SUBDIVISION REVIEW SHEET**CASE NO.:** C8-2021-0050.0A**COMMISSION DATE:** June 20, 2023**SUBDIVISION NAME:** 607 Montopolis Dr Subdivision**ADDRESS:** 607 Montopolis Dr**APPLICANT:** Sean Murphy (L4S, LLC)**AGENT:** Grant Geissinger (Southwest Engineers, Inc.)**ZONING:** SF-3-NP (single family residence)**NEIGHBORHOOD PLAN:** Montopolis**AREA:** 0.939 acre (40,848 sf)**LOTS:** 5**COUNTY:** Travis**DISTRICT:** 3**WATERSHED:** Country Club East**JURISDICTION:** Full Purpose**SIDEWALKS:** Sidewalks will be constructed along Montopolis Drive and Thrasher Lane.**DEPARTMENT COMMENTS:**

**CITY OF AUSTIN –DEVELOPMENT SERVICES DEPARTMENT
SUBDIVISION APPLICATION – MASTER COMMENT REPORT**

CASE NUMBER: C8-2021-0050.0A
UPDATE: U1
CASE MANAGER: Joey de la Garza PHONE #: 512-974-2664

PROJECT NAME: 607 Montopolis Drive Subdivision
LOCATION: 607 MONTOPOLIS DR

Exhibit B: Proposed plat

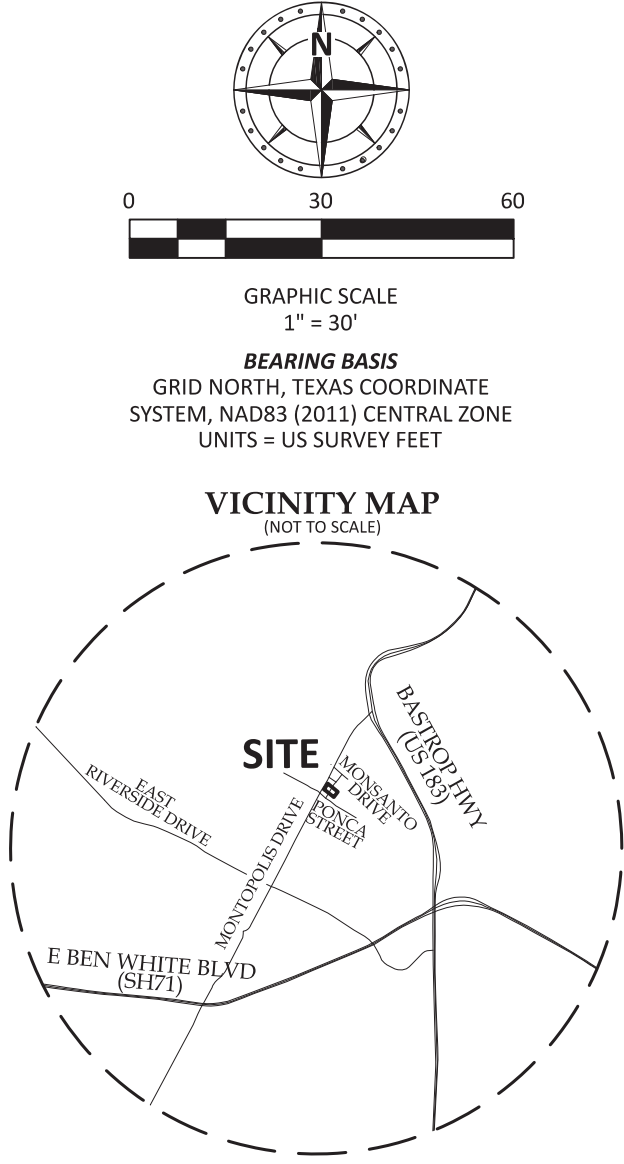
In order to clear this comment, please submit a formal update showing the easements on the proposed plat that were discussed in meeting on 6/8/2023.

AD2: Please indicate whether the joint use access easement will be named and reserve the names if so.

ATD.4. Driveways must be separated from adjacent driveways by at least 50 feet. TCM, Table 7-5. *Please show the spacing from the adjacent driveway on Thrasher Lane.*

Comment stands as this was not depicted on the plat with the last update. In relation to this comment, please submit a digital drawing to this reviewer illustrating that each proposed lot in this subdivision will have a 50'x50' buildable area within their respective boundaries and within the applicable building setback lines.

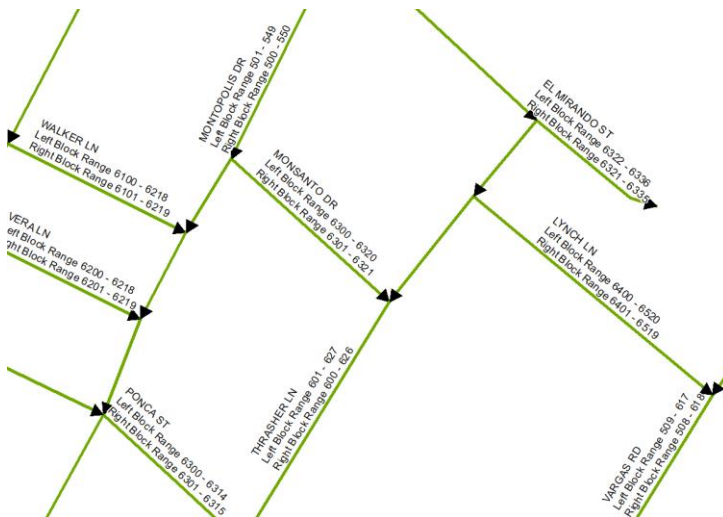
AD3: Pre-Directionals are used when a street crosses over designated zero range boundaries should be represented by a single letter, (not spelled out), and appear before the street name. Please replace the labels EAST RIVERSIDE DR with **E RIVERSIDE DR** and resubmit.

AD4: MONSANTO DR is misrepresented on the vicinity map. Either replace the label MONSANTO DR with EL MIRANDO ST or remove it entirely
